DOCKETED	
Docket Number:	01-EP-10C
Project Title:	Enterprise Emergency Peaker Project - Compliance
TN #:	268056
Document Title:	CEC Data Response - Enterprise Hazardous Materials, Worker Safety, and Fire Protection - Vol 3_App D-G
Description:	Response to Data Request for Enterprise Emergency Peaker Project, Docketed Date 11/4/2025 (Volume 3 of 3).
Filer:	Grace Myers
Organization:	Rincon Consultants, Inc.
Submitter Role:	Applicant Consultant
Submission Date:	12/29/2025 12:17:16 PM
Docketed Date:	12/29/2025

Appendix D1

Email Correspondence with Chief Batson

La Vona Guidance re: Site Plan Layout, Access, and Setbacks (CEC DR 13)

Fire Access Plan

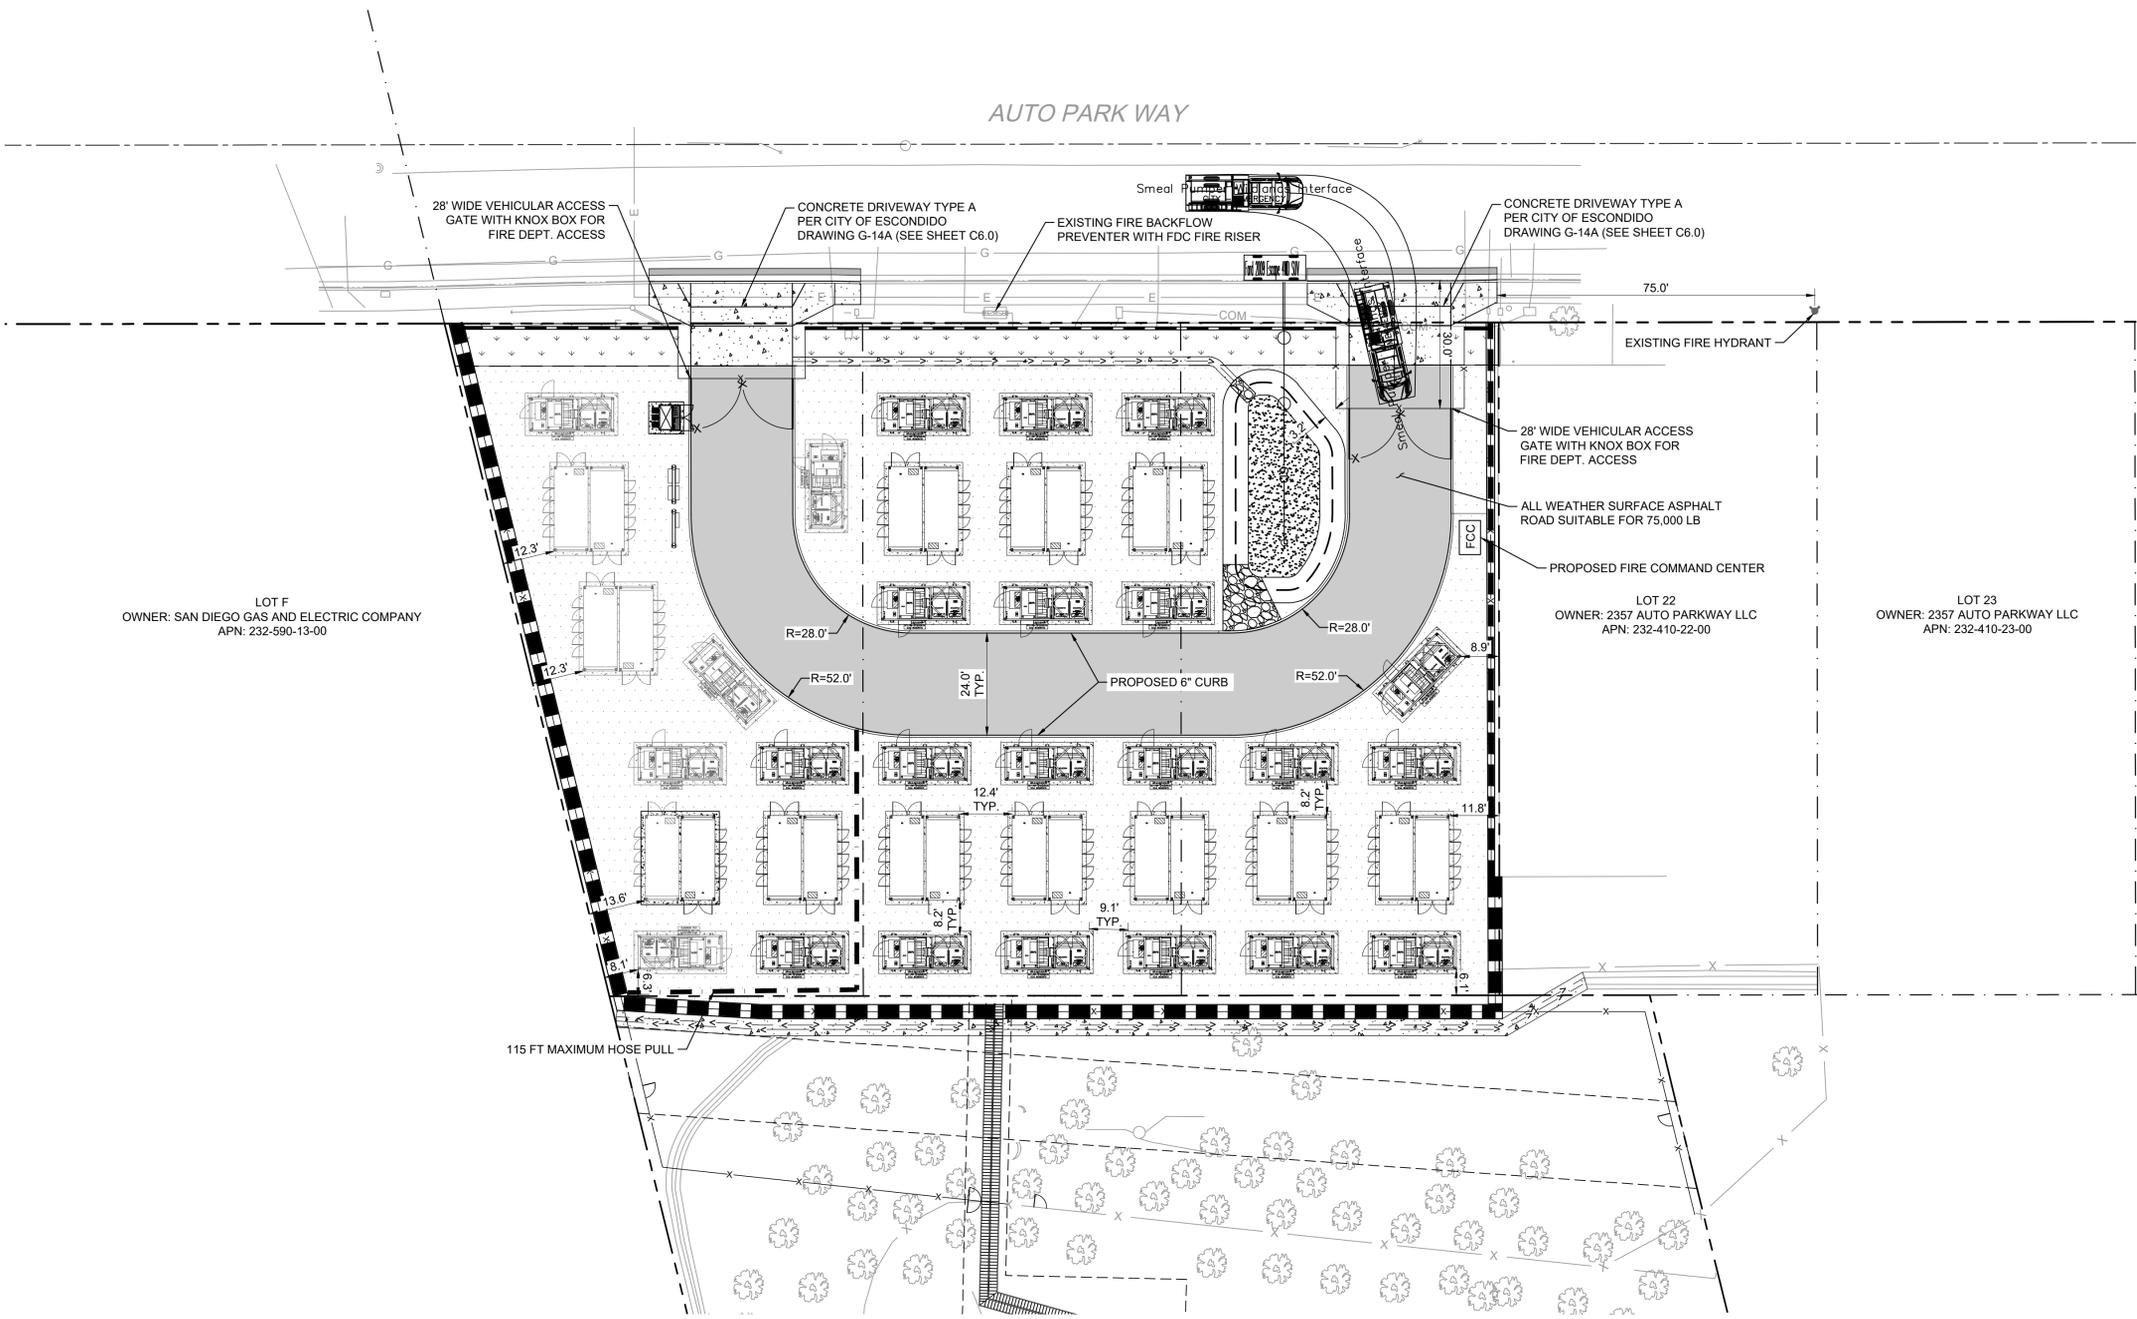
- Asphalt pavement is preferred by Fire Department vs gravel. Applicant noted that site plan design is asphalt access road.
- Discussed adding an annotation to the site plan to show turning radii for the internal access road (La Vona noted it appears adequate but should confirm and label).

- With the modification to the site plan access design to recess the eastern driveway entrance to 30 feet to accommodate the standard 28-foot long fire trucks without protruding into Auto Park Way, the site access for fire department is expected to be adequate. The applicant will provide the revised layout with recessed access and labeled turn radii to the fire department for review.

In addition, please find attached the revised Fire Access Site Plan that addresses your comments regarding the fire truck clearance for the eastern site entrance, setback labeling, etc.
